Trinity Islands Site C, Manchester

Non-Material Amendment | 21.01.2026

ZC-SHP-A180-RP-XX-NMA01 | P01

Updated proposal : Site C Building 2 - Eleavtions 01 - C2-SHP-G200-EL-XX-B5D801 - P03

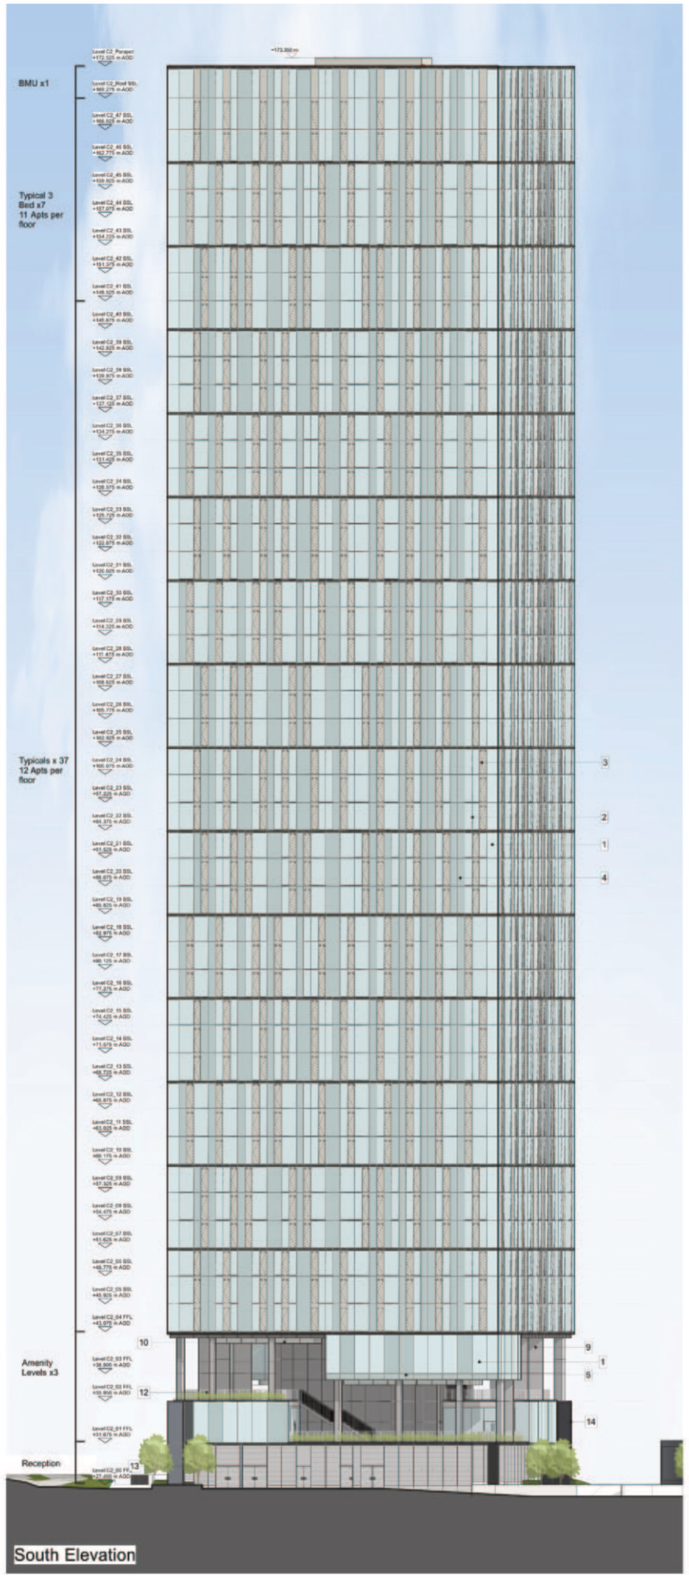
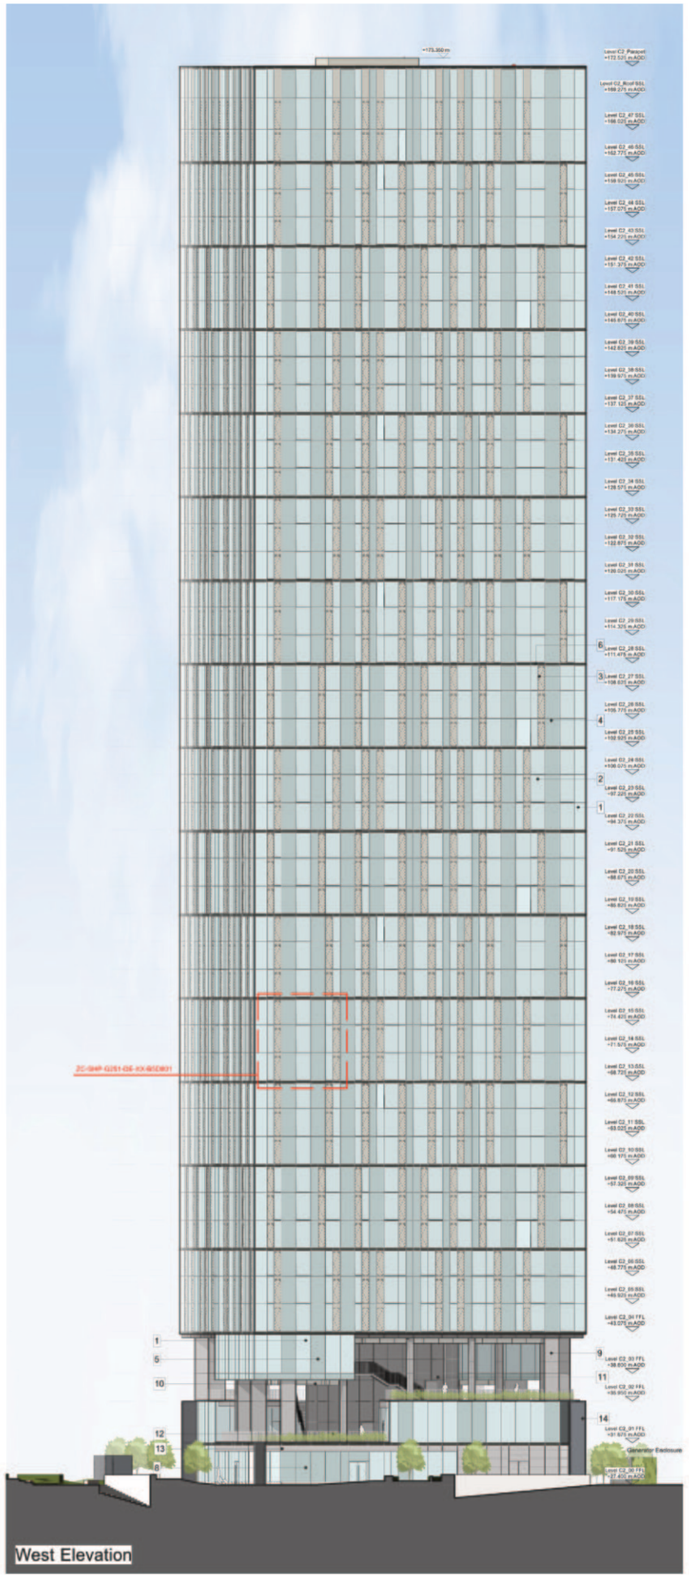
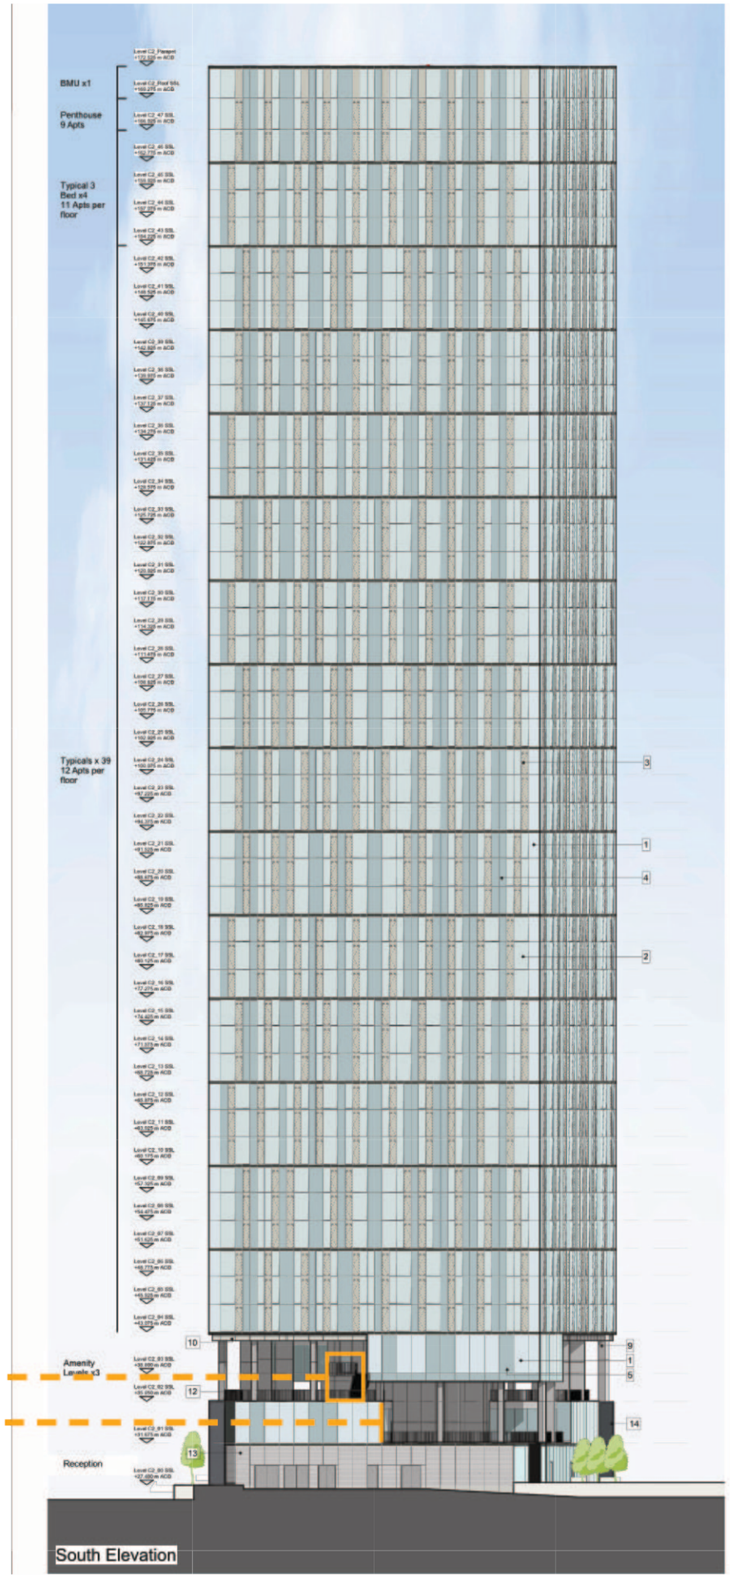
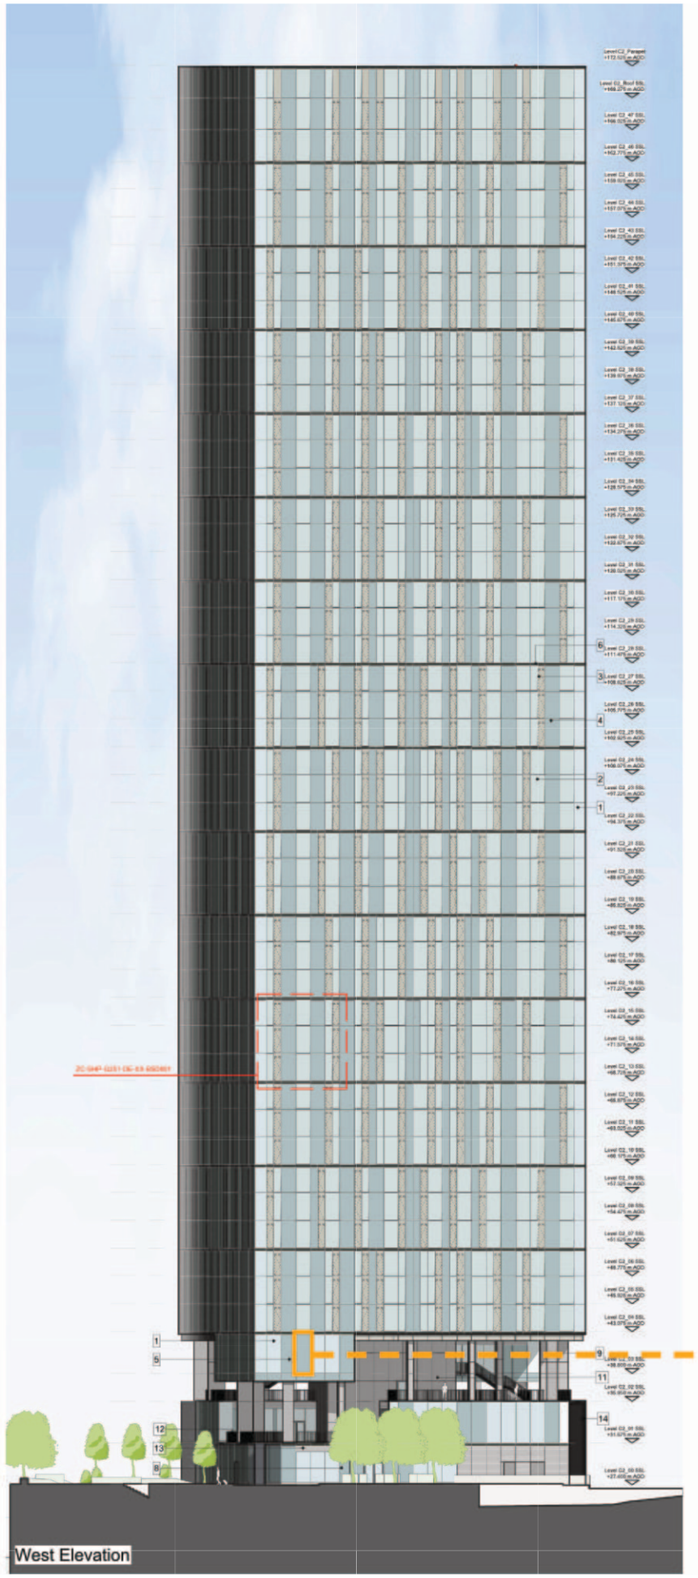
4. External stair/walkway updated

5. Facade line updated

5. Additional opaque panel

Updated proposal : Site C Building 2 - Eleavtions 02 - C2-SHP-G200-EL-XX-B5D802 - P03

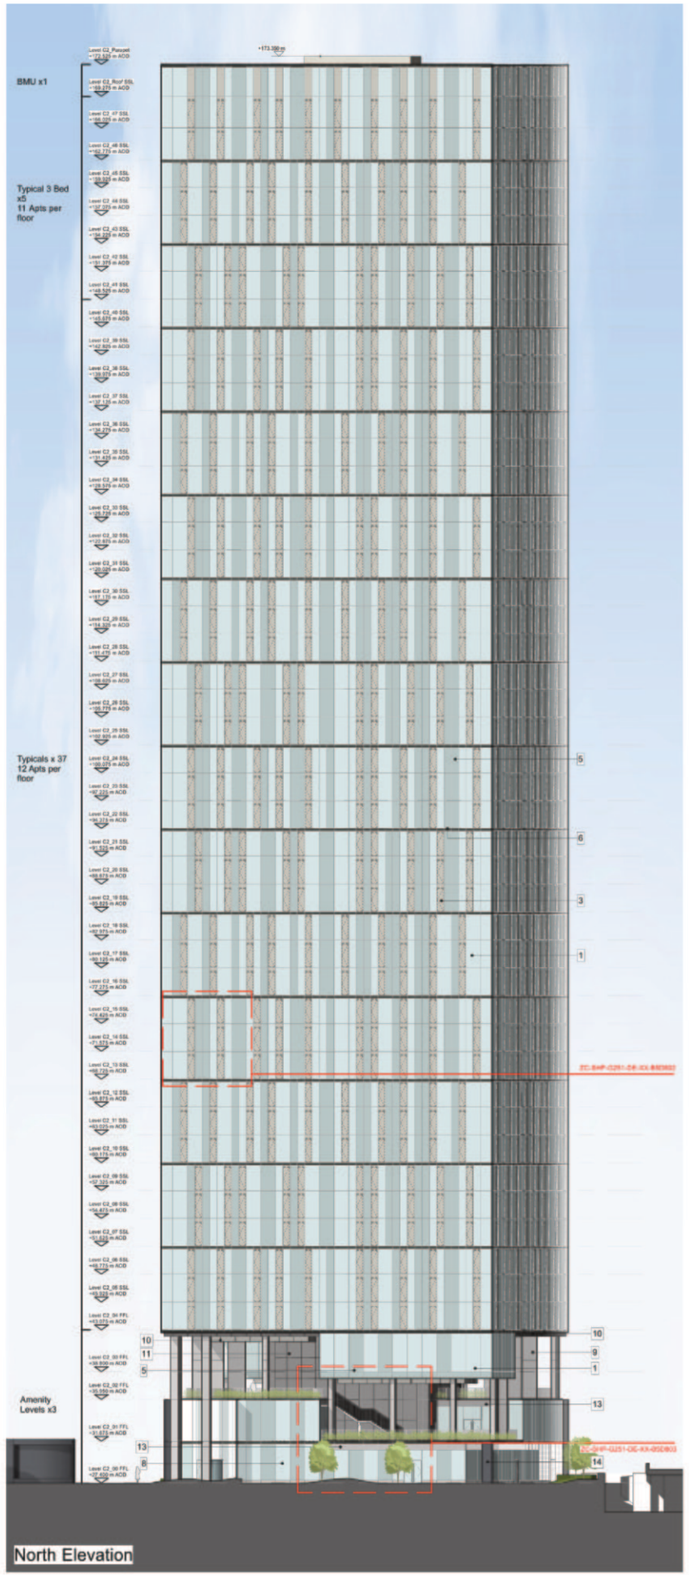
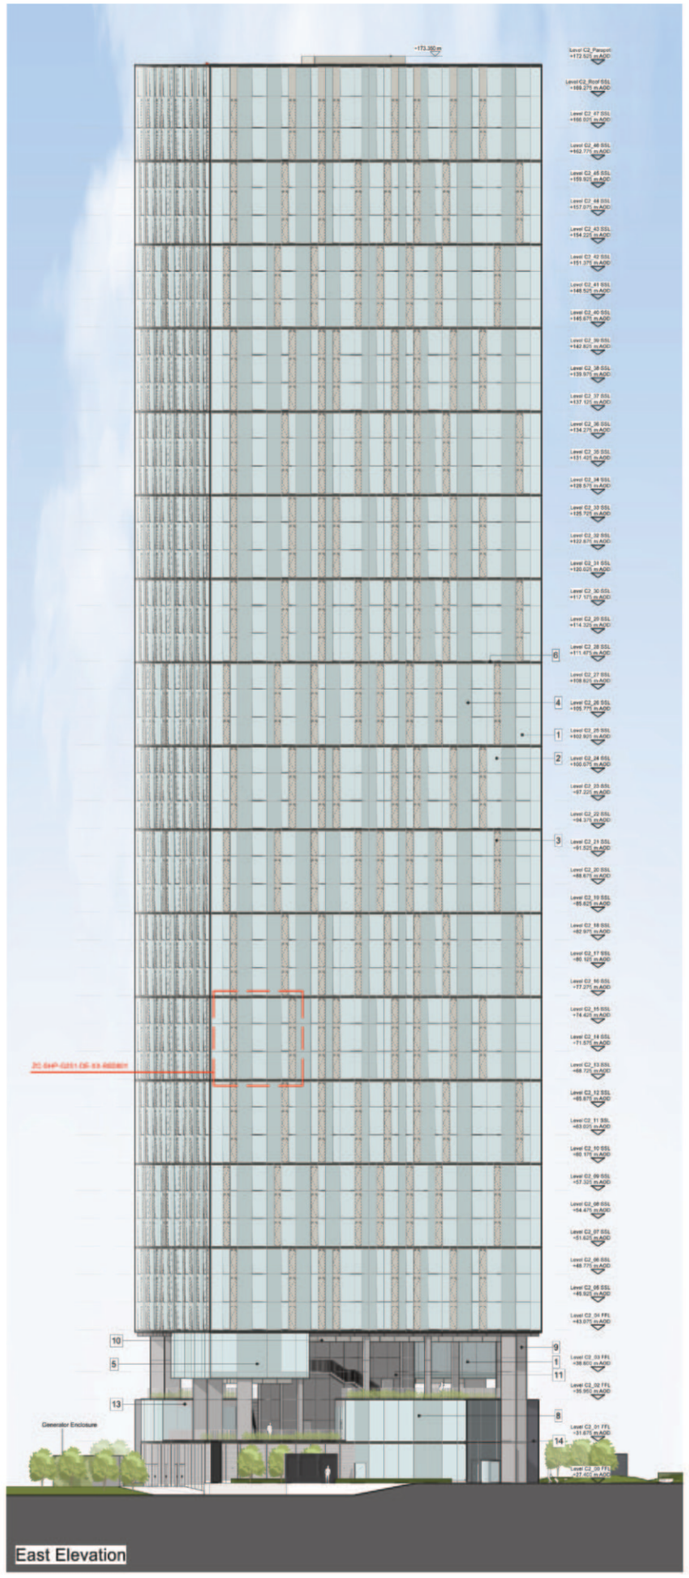
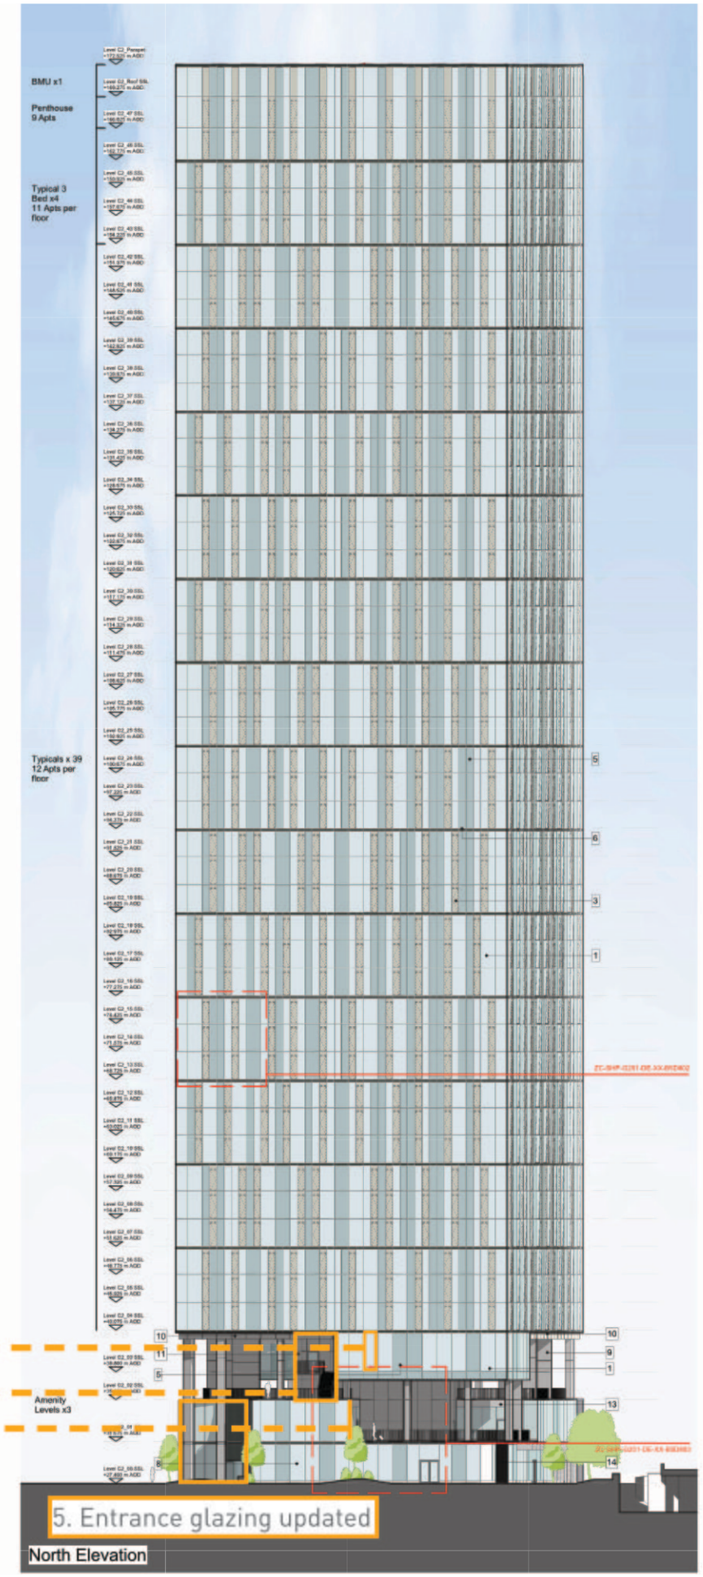
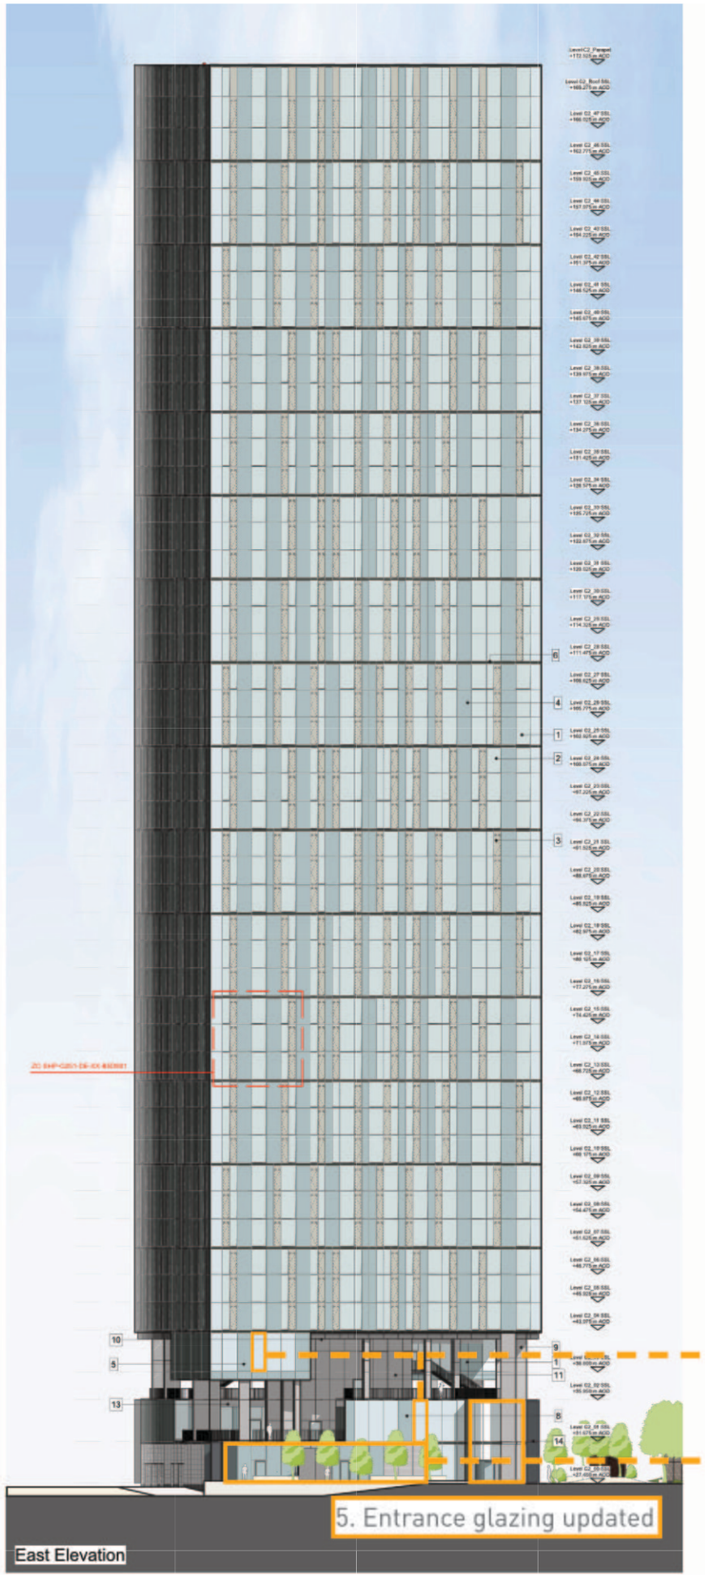
5. Additional clear panel

4. External stair/walkway updated

5. Facade line updated
